# **SAFETY EVALUATION REPORT**

## for the Nichols Ranch In Situ Recovery Project in Johnson and Campbell Counties, Wyoming Materials License No. SUA-1597

Docket No. 040-09067  
URANERZ ENERGY CORPORATION

**U.S. Nuclear Regulatory Commission**

Figure 2.4.1-1 Nichols Ranch Unit and Hank Unit drainage areas

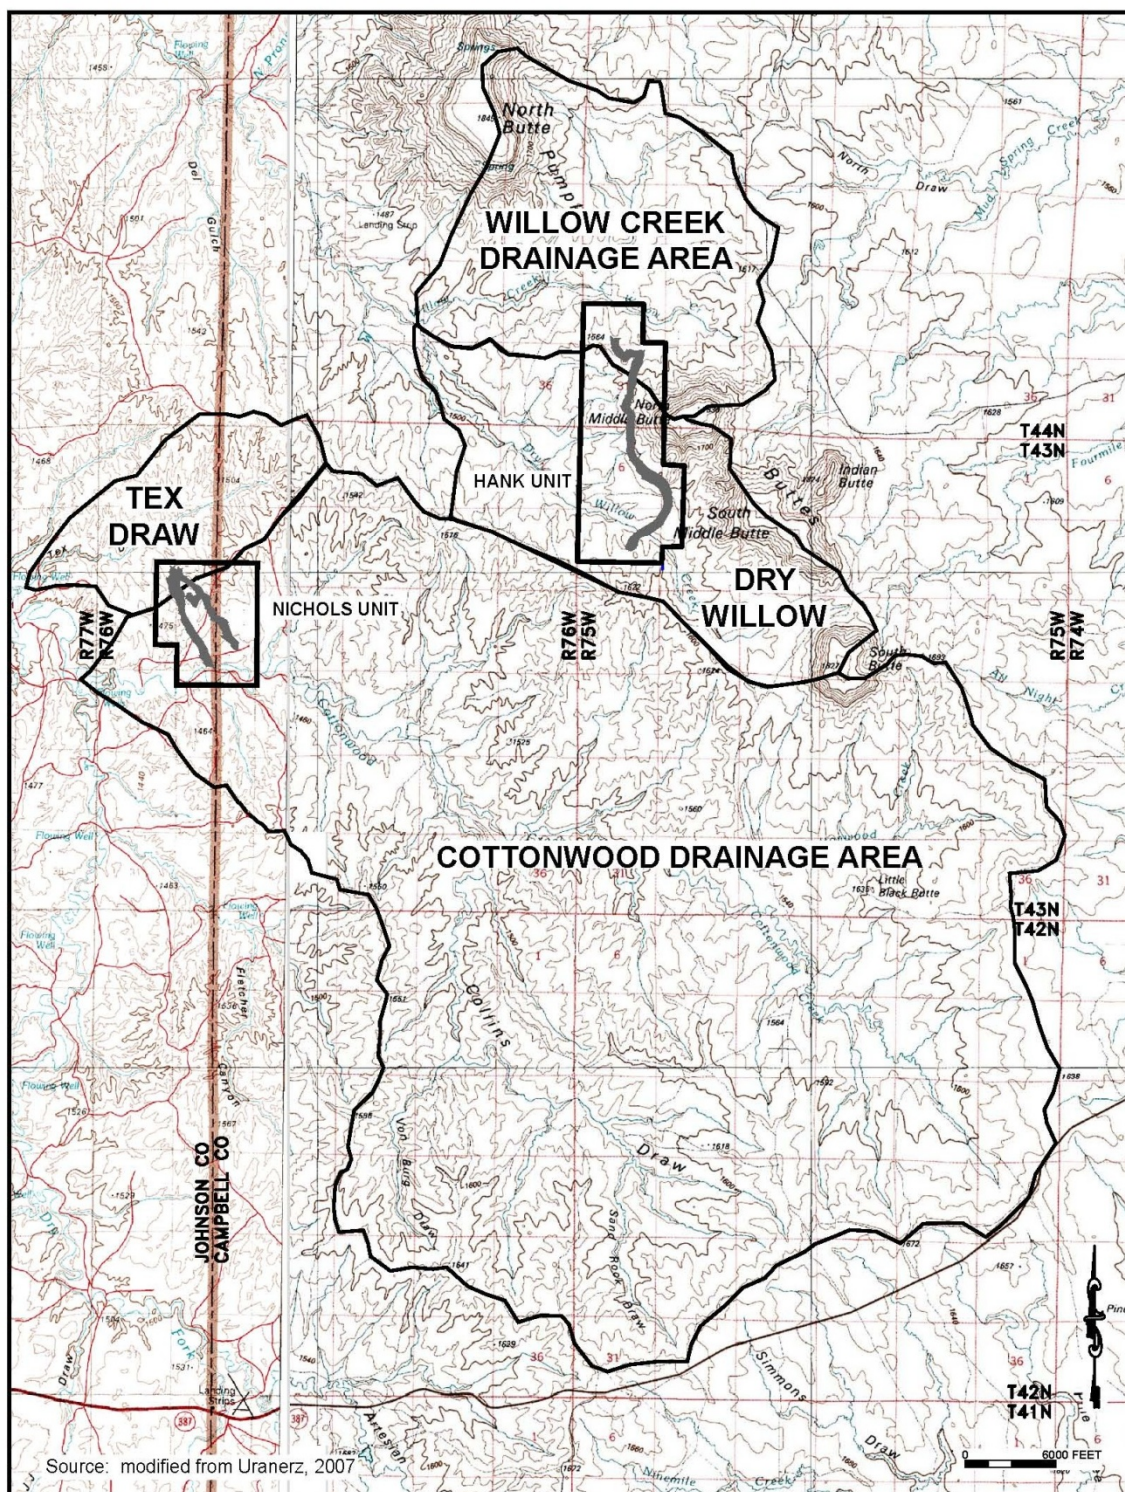
The applicant described the surface water hydrology for the proposed Nichols Ranch Unit. The majority of the Nichols Ranch Unit license area lies within the Cottonwood Creek drainage, which covers 208 km<sup>2</sup> (80.2 mi<sup>2</sup>) (SER Figure 2.4.1-1). Cottonwood Creek is a tributary to the Dry Fork of the Powder River and flows from east to west through the southern portion of the license area and enters the Dry Fork about 0.81 km (0.5 mi) downstream of the project area. The northwestern corner of the license area lies within the Tex Draw drainage, which occupies 13.5 km<sup>2</sup> (5.2 mi<sup>2</sup>). Tex Draw flows from the northeast to the southwest, north of the license area. Tex Draw is also a tributary to the Dry Fork of the Powder River and enters Dry Fork about 3.2 km (2.0 mi) downstream of the license area. Powder River is a tributary of the Yellowstone River (Uranerz, 2007).

The applicant defined six smaller drainage basins numbered by the applicant as NDA1 through NDA6 (presumably NDA is an acronym for Nichols Drainage Area, but this term is not defined by the applicant) in the Nichols Ranch Unit license area as shown in application Figure 2-15. Each of these drainage areas has an ephemeral stream that is a tributary of Cottonwood Creek. Tributaries in NDA2, NDA3, and NDA4 cross the planned well fields flowing from northeast to the southwest.

The applicant reported that Cottonwood Creek, Tex Draw, and the smaller tributaries in the license area are all classified as ephemeral streams that flow only in response to heavy snowmelt and large rainfall events. Peak flows were estimated for recurrence intervals of 5, 10, 25, 50, and 100 years for the Cottonwood Creek and Tex Draw using the methods of Lowham (1976), which were developed for and are suited to drainages of this size. The peak flows were also estimated for all of the smaller drainage areas using the method of Craig and Rankl (1978). This method was devised using field data from small drainages in Wyoming to develop empirical relationships to assess peak flow rates. The NRC staff finds methods developed from empirical data measured in similar drainages to provide the best estimate for these types of small drainages. SER Table 2.4.1-1 shows the peak rate values from these calculations. Staff reviewed the values provided by the applicant and agrees with the calculations and the methodology used.

The Hank Unit lies within the Dry Willow and Dry Willow Creek drainages, as shown in SER Figure 2.4.1-1. The Dry Willow drainage occupies 31.6 km<sup>2</sup> (12.2 mi<sup>2</sup>) and discharges to Dry Willow Creek, which flows from the southeast to northwest, traversing the southern portion of the license area. It enters Willow Creek approximately 3.2 km (2 mi) west of the license area. The northern portion of the Hank Unit lies within the Willow Creek drainage which covers 34.2 km<sup>2</sup> (13.2 mi<sup>2</sup>). It drains directly into Willow Creek, which flows from east to west through the northern portion of the license area. Willow Creek is a tributary of the Powder River and enters the Powder River approximately 26 km (16 mi) downstream of the Hank Unit (Uranerz, 2007).

The applicant described eight smaller drainage basins numbered HDA1 through HDA8 (presumably HDA is an acronym for Hank Drainage Area, but this term is not defined by the applicant) in the Hank Unit license area as shown in application Figure 2-15. Each of these drainages contains an ephemeral stream, which is a tributary to Dry Willow Creek in the south

Figure 2.4.2-1 Potentiometric surface in the Nichols Ranch Unit “A sand” aquifer in 2008 (modified from application Figure D6-5)

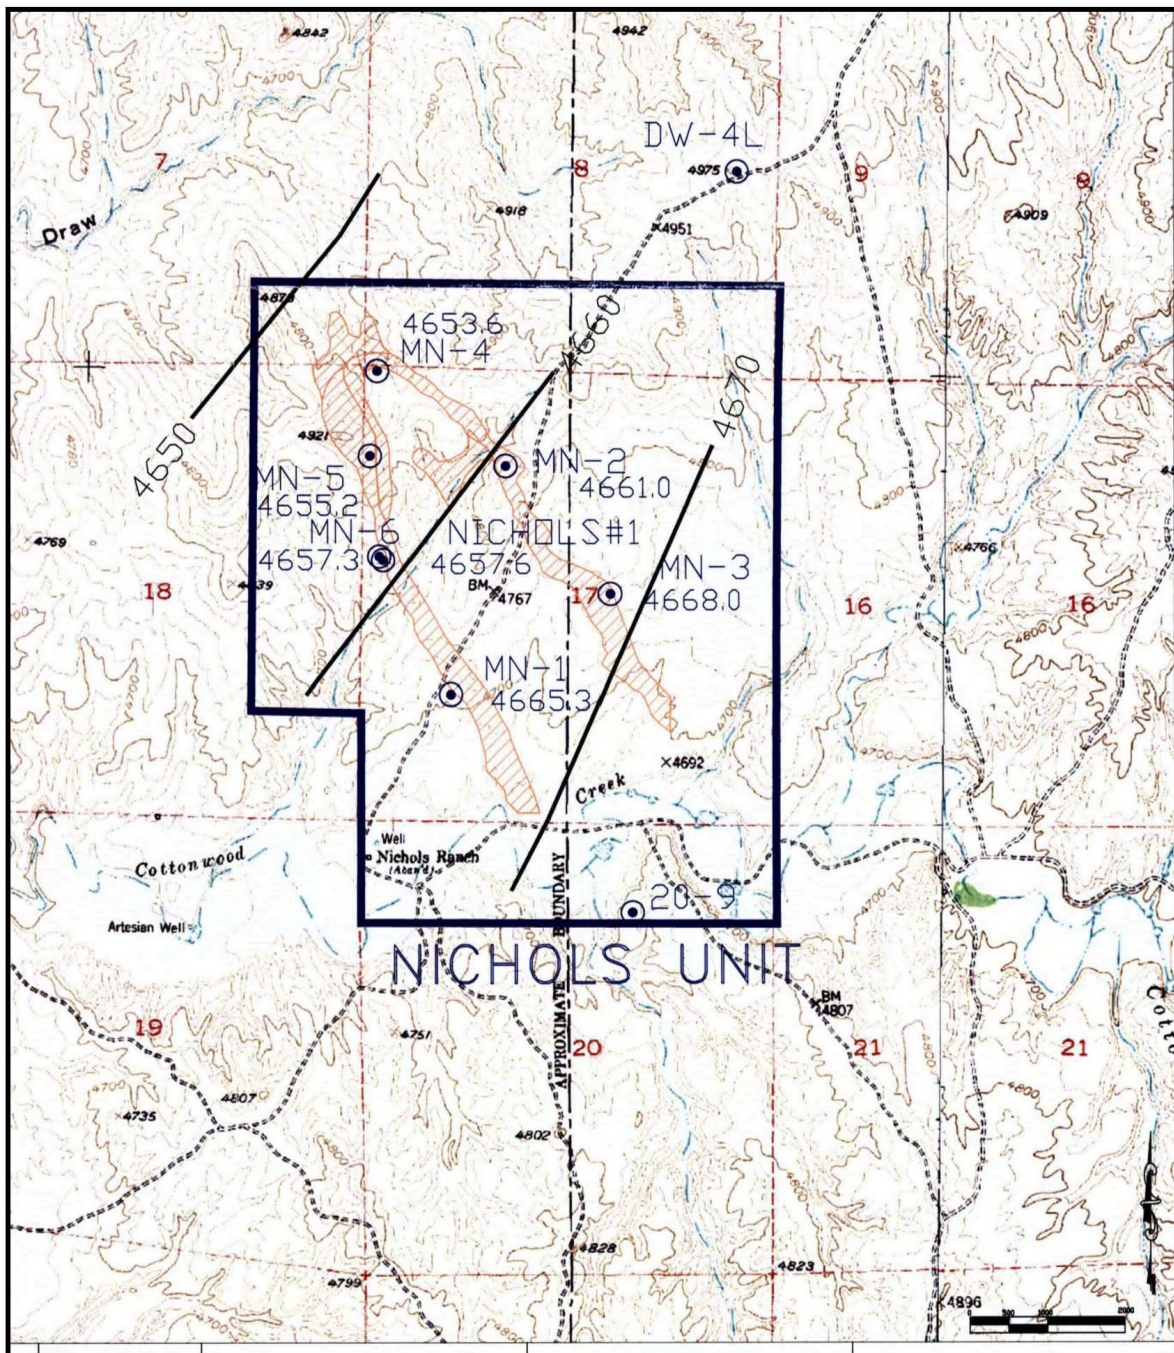
The applicant reported that below the "B sand" aquifer is the "A sand" aquifer, which is the ore zone in the Nichols Ranch Unit license area. The applicant used seven wells (MN-1, MN-2, MN-3, MN-4, MN-5, MN-6, and Nichols 1), shown in SER Figure 2.4.2-1, to measure water levels in the "A sand." Water levels in the "A sand" demonstrate that the aquifer is a confined (saturated) aquifer, with a potentiometric surface rising approximately 122 m (400 ft) above the top of the sand. Based on the potentiometric contours, the applicant reported the ground water flow direction in the "A sand" is to the northwest with a gradient of 0.0033. Application Figures D6D.1-1 and D6D1-2 show the variation in water level over time for these wells. The staff reviewed these figures, which indicate that the water levels were relatively steady over the period from late 2006 to the beginning of 2010.

**Figure 2.4.2-2 Water wells within a 0.81-km (0.5-mi) boundary of the Nichols Ranch Unit (modified from application Figure 2-17)**

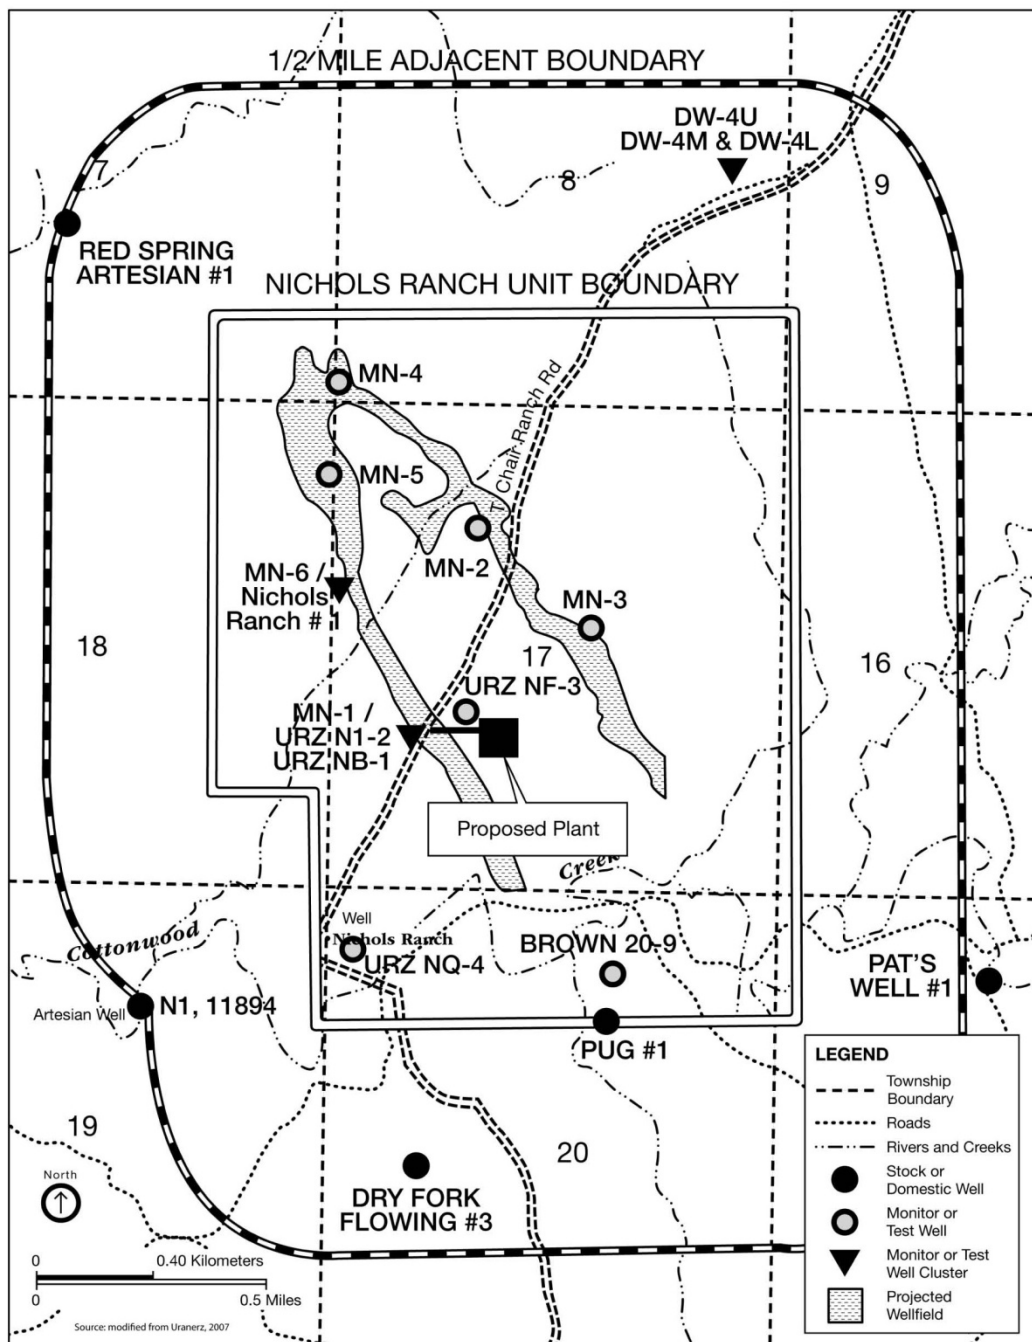
The applicant provided a map of water wells within 0.81 km (0.5 mi) of the Nichols Ranch Unit license area, as shown in SER Figure 2.4.2-2. Application Table D6-2 provides completion data for these wells, including the aquifers in which they are screened. Based on a search of the water permit database of the Wyoming State Engineers Office for this area, the staff found that the majority of wells are stock wells or monitoring wells. No water wells permitted for domestic use are located within this 0.81-km (0.5-mi) boundary. The applicant also presented a map of all permitted wells within a 4.8-km (3-mi) radius in application Exhibit D6-1 and the associated ground water permits in application Table D6G.1-2. According to the table, the majority of wells are stock or monitoring wells. Two domestic wells, Doughstick #3 and Garden Well, are located approximately 3.2 km (2 mi) southeast of the license area. One other domestic well, Dry Fork #1, associated with a residence at Dry Fork Ranch, is located approximately 1.6 km (1 mi) to the west of the license boundary. The depth of this well is unknown.

The applicant established the site preoperational ground water quality in the Nichols Ranch ISR Project area from data collected by recent sampling in 2006, 2007, and 2008, and prior sampling completed in the late 1970s and early 1980s. Application Table D6E.1-1 presents information on ground water quality from wells in the Nichols Ranch Unit. Application Table D6-2 presents completion data from these wells. SER Figure 2.4.2-2 shows the locations of the wells.

Figure 2.4.2-3 Water levels in the "F sand" ore zone in the Hank Unit (application Figure 2-20b)

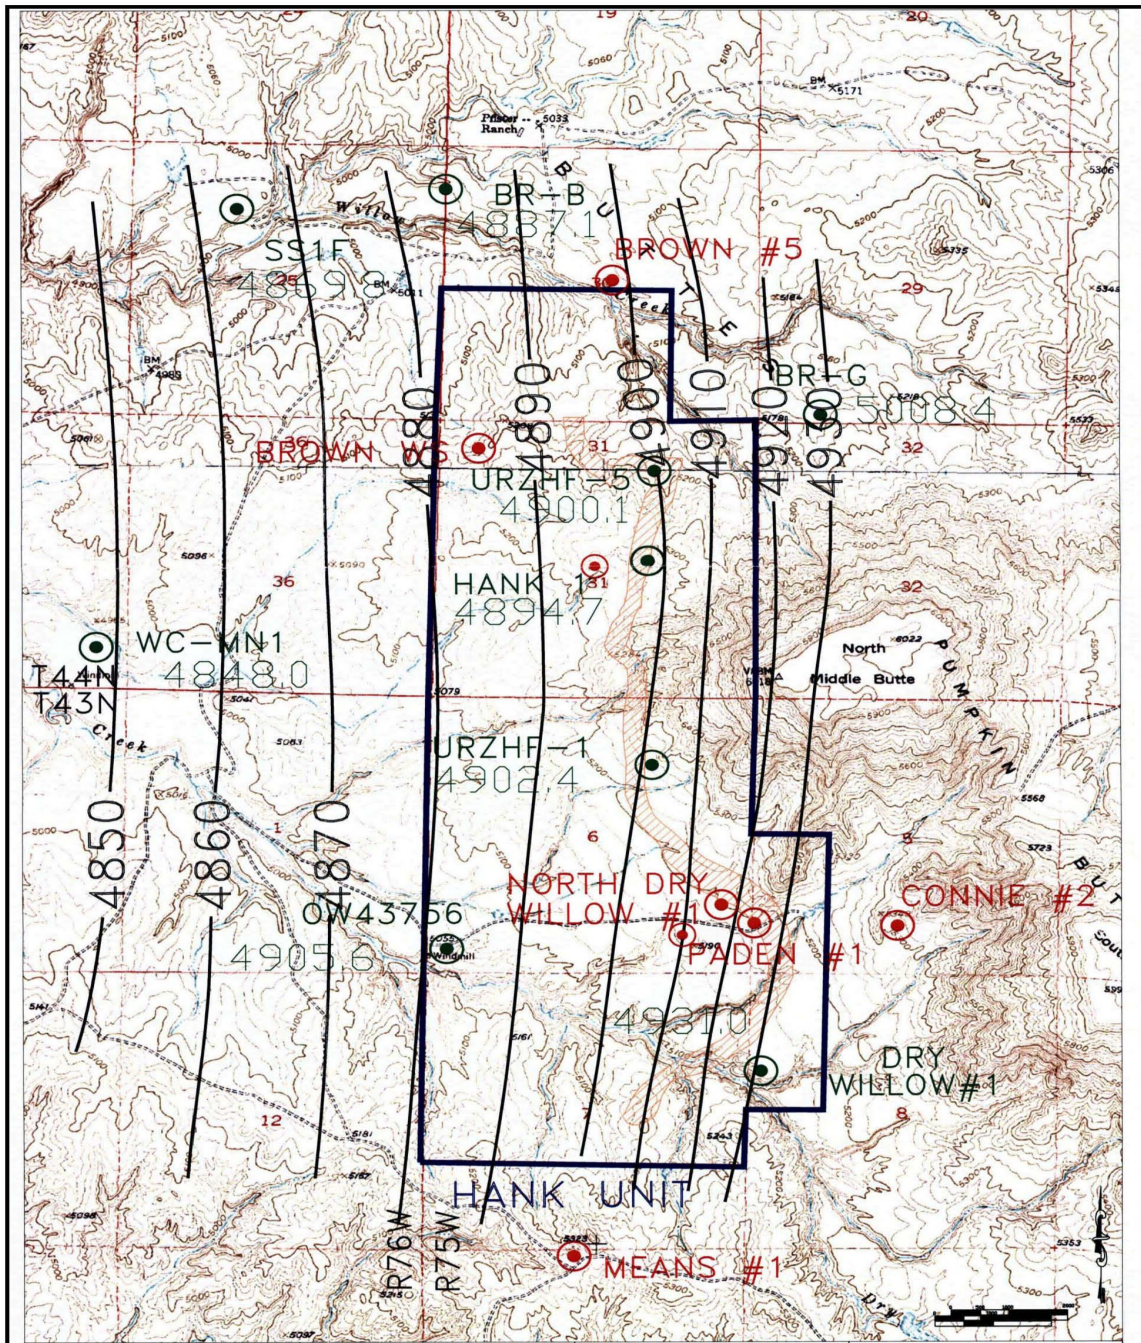
Underlying the “G sand” is the “F sand,” which is the ore zone in the Hank Unit. The applicant measured water levels in 11 wells over time in the “F-sand.” Time series plots of some of the wells are shown in Figures D6D2-1 through D6D2-4 in the application from late 2006 to late 2009. The staff reviewed these figures, which demonstrate that water levels have remained steady. The applicant provided the water-level contours for the “F sand,” as shown in SER Figure 2.4.2-3. Based on the contours, the applicant estimated the gradient in the “F sand” to be 0.005 to the west. Water levels in the “F sand” fall below the base of the overlying G-F aquitard in the northern portion of the license area and are slightly above in the southern portion. The applicant stated that the “F sand” is both an unconfined (unsaturated) and confined (saturated) aquifer across the Hank Unit license area, and staff agrees with this assessment.

**Figure 2.4.2-4 Water wells within a 1/2-mile boundary of the Hank Unit**

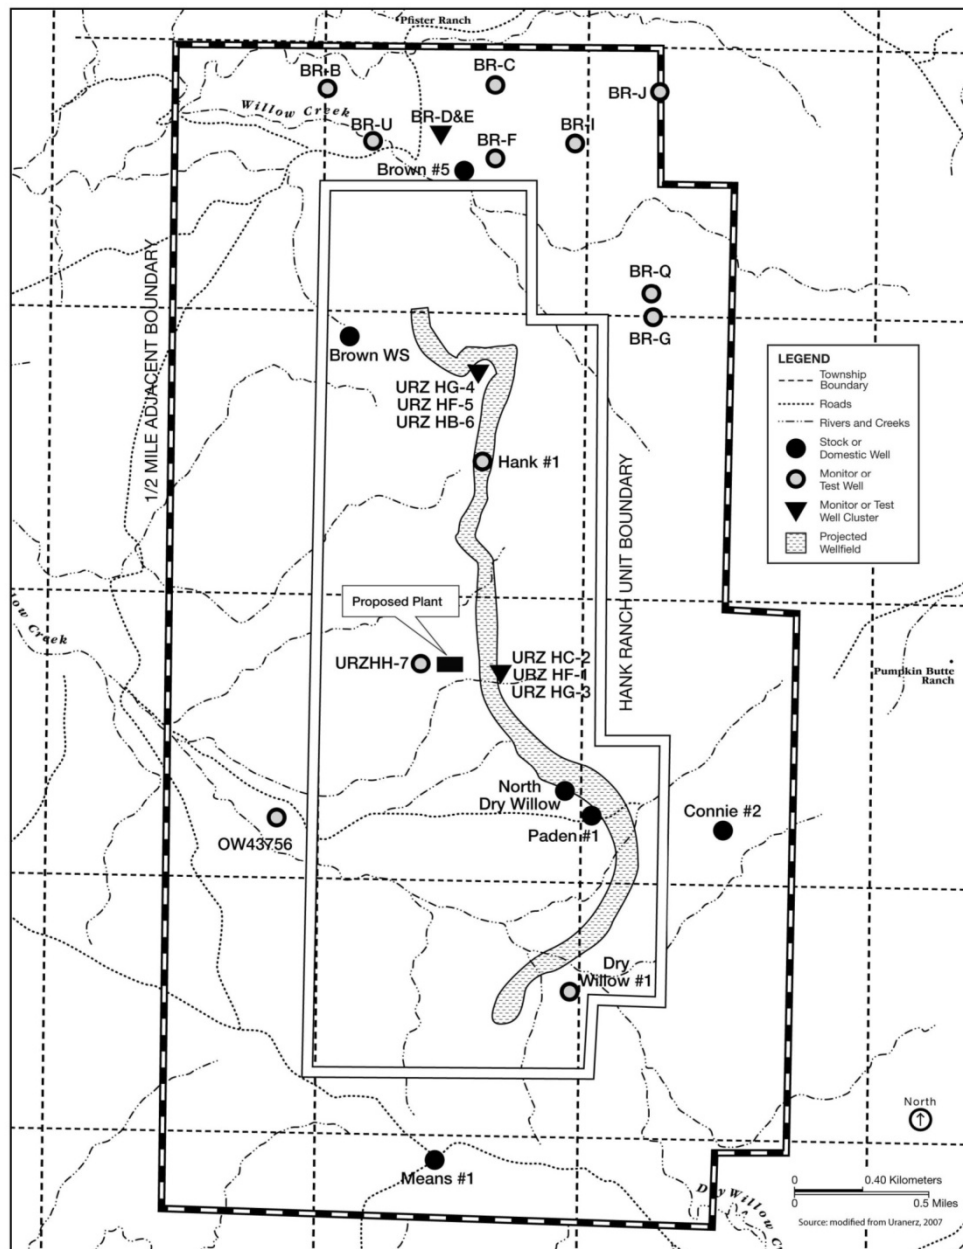
The applicant provided a map of water wells within 0.81 m (0.5 mi) of the Hank Unit license area, as shown in SER Figure 2.4.2-4. Application Table D6-3 provides completion data for these wells, including the aquifers in which they are screened. Based on a search of the database of ground water permits and well descriptions for this area in the Wyoming State Engineers Office, the staff found that the majority of wells are stock wells or monitoring wells. No water wells permitted for domestic use are located in this 0.81-km (0.5-mi) boundary area. The applicant also presented a map of all permitted wells within a 4.8-km (3-mi) radius in application Exhibit D6-2 and the associated ground water permits in application Table D6G.2-2. According to this table, the majority of wells are stock or monitoring wells.

Application Table D6E.1-2 presents ground water quality data from wells in the Hank Unit. Application Table D6-3 provides completion data for these wells, and SER Figure 2.4.2-4 shows the location of the wells. Ground water quality parameters measured for both license areas include all suggested analytes in SRP Table 2.7.3-1, except silver. The application included data from three to four rounds of water sampling in 2006, 2007, or 2008 for most wells. The applicant provided tables summarizing the ground water quality for wells in the overlying, underlying, and ore zone aquifers at both the Nichols Ranch and Hank Units in application Table D6-6.
